Addendum to Environmental Impact Report

Addendum Date: July 22, 2013
Case No.: **2005.0161E**
Project Title: Calaveras Dam Replacement Project
EIR: 2005.0161E, certified January 27, 2011
Project Sponsor: San Francisco Public Utilities Commission
Lead Agency: San Francisco Planning Department
Staff Contact: Chris Kern – (415) 575-9037
chris.kern@sfgov.org

RE: **Memorandum on the Placement of NOA-Containing Materials within Calaveras Reservoir below the 756 foot elevation at Calaveras Dam Replacement Project (CDRP)**

DISPOSAL SITE I
SECTIONS

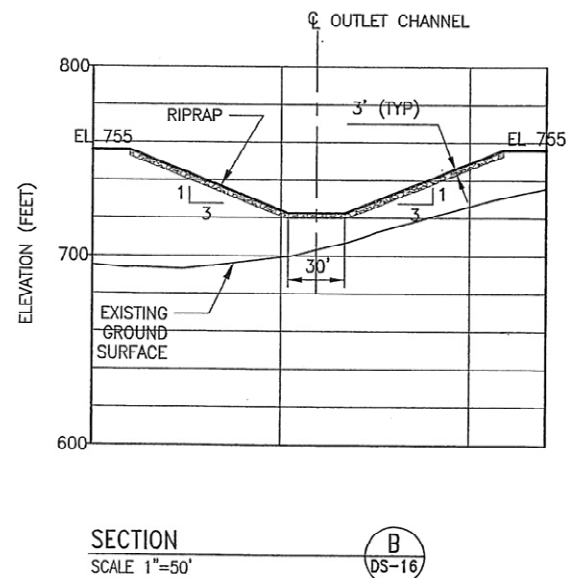
Additionally, the SFPUC proposes to relocate the hard rock previously planned to protect the toe of the fill at Disposal Site 3, as described in the EIR, to the face of the fill at Disposal Site I due to the modified configuration of the disposal areas as described in the previous addendum to the EIR issued on December 13, 2012 (see below). The same hard rock material would be used.

The proposed modification to place the hard rock along the face of the fill at Disposal Site I for erosion protection instead of at Disposal Site 3 due to the reconfiguration of these sites in the previous addendum would not constitute a substantial change from the adopted project because the same rock would be used at the same location relative to the future water inundation zone (i.e., at the edge of the water line). The conclusions reached in the EIR for

DISPOSAL SITE F
ROAD PROFILE & SECTIONS

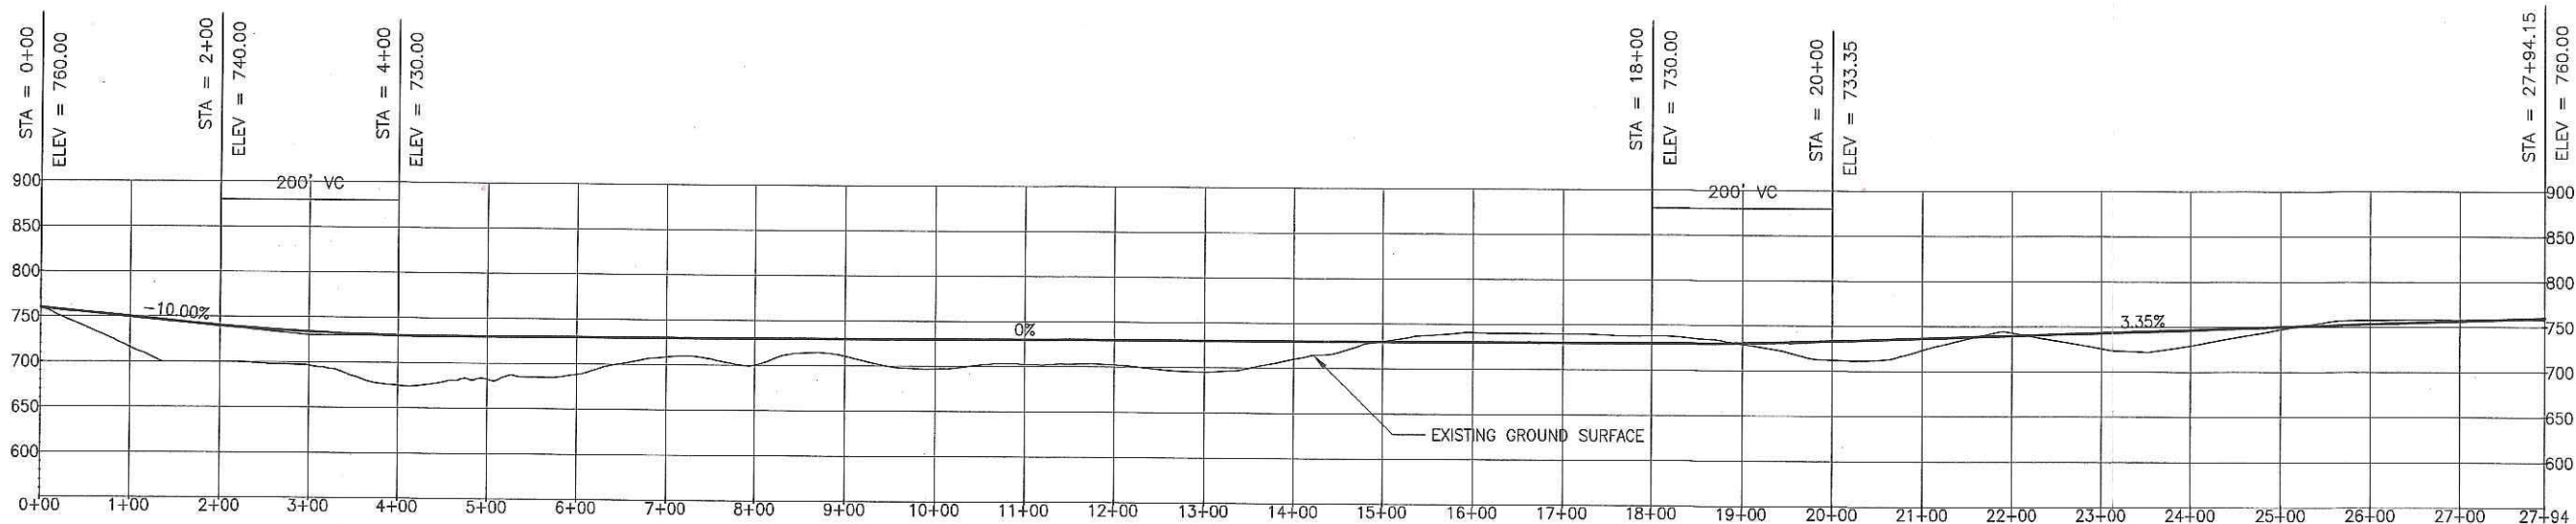
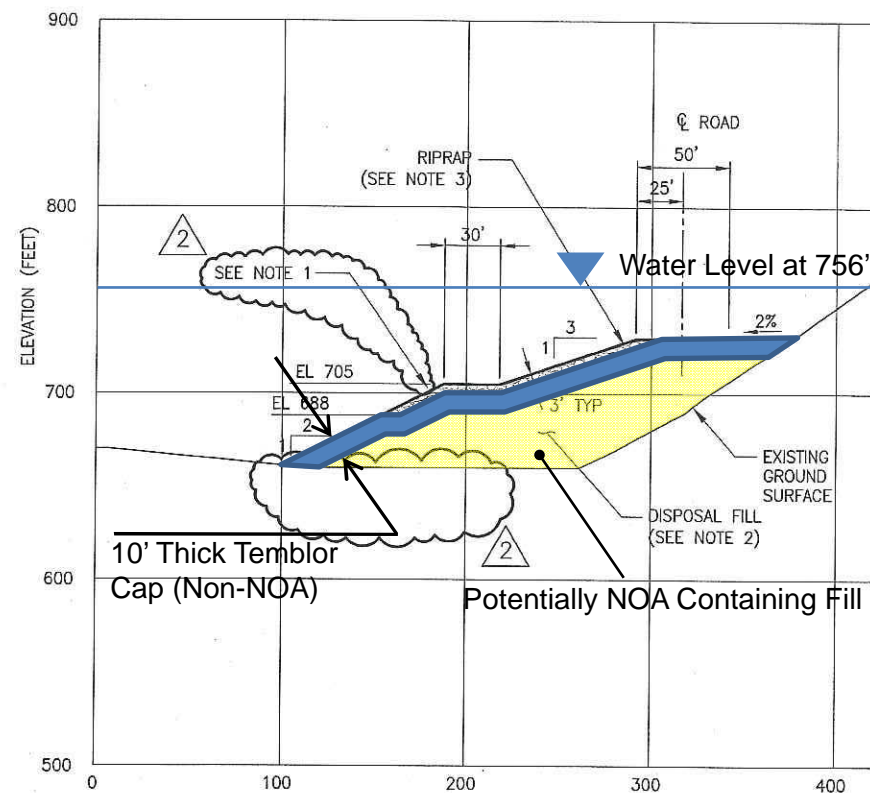
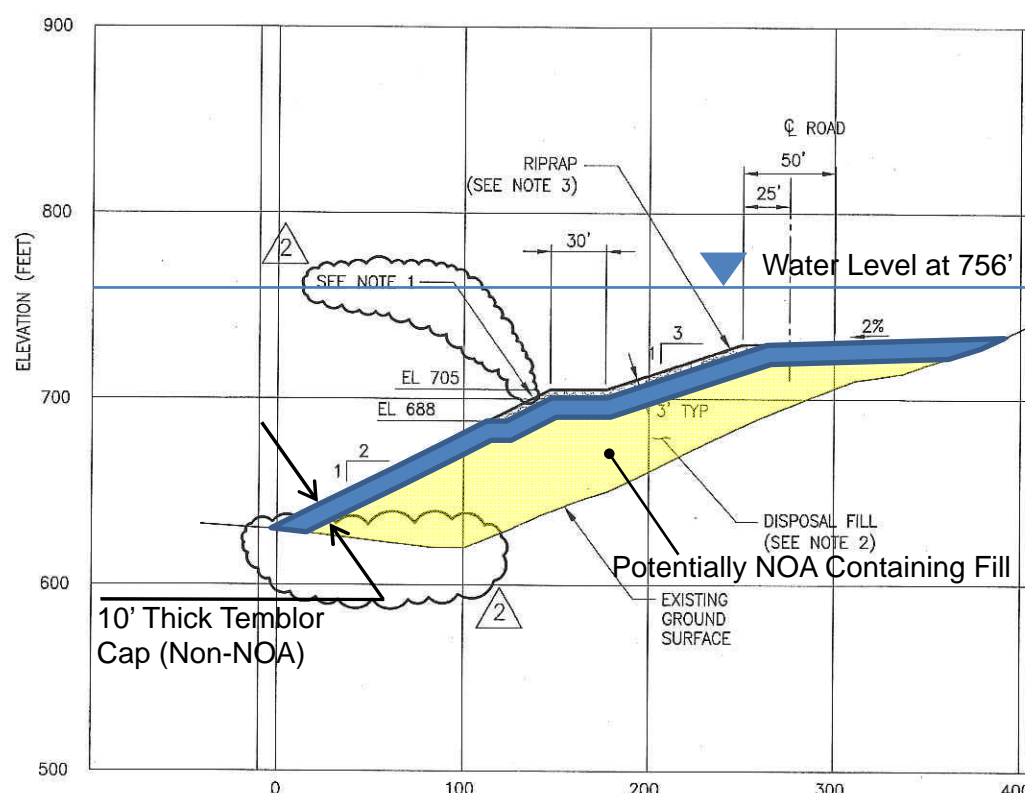
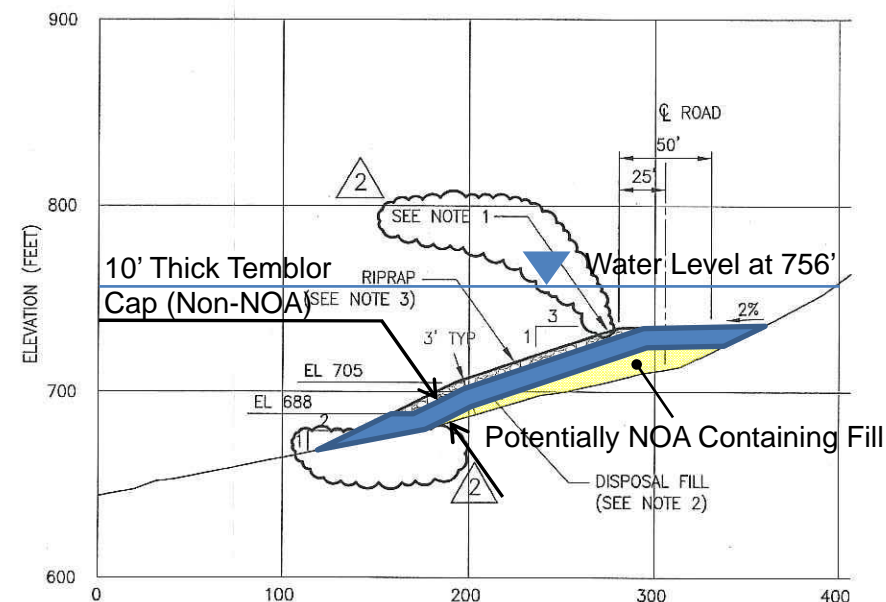
Placement of this material at Disposal Sites F and I would result in approximately 390,000 CY of NOA and metal containing fill materials below the 756-foot future inundation area of the restored reservoir. The SFPUC would place the NOA-containing materials in areas of the disposal sites that are dry during construction and would cap the NOA-containing materials below a 10-foot thick layer of Temblor Sandstone. Placing the materials at these disposal sites would be a modification from the adopted project, which specified that with the exception of rockfill from the upstream side of the existing dam and the toes of the disposal sites, excavated materials that may potentially contain NOA would only be placed in the disposal sites at or above Elevation 760 feet, a minimum of 4 feet above the future inundation area of the restored reservoir.

The migration from NOA containing materials disposed at Disposal Site F and I below the 760' water line will be mitigated by capping the material with Temblor formation sands or other NOA-free materials. The proposed design of Disposal Site F and I specifies an outer 10 foot cap of Temblor formation sand (see Attachment B-Disposal Site F and I) to prevent release of fibers. This outer shell would filter long asbestos fibers and prevent them from migrating to the reservoir. In this particular location and other disposal sites, the Temblor cap will be protected from erosion by a shell of blueschist rip rap mined from Borrow Area B onsite. The use of NOA-bearing blueschist is permitted to be used for this purpose (see Regional Water Quality Control permit application, page 2-11, October 2009).
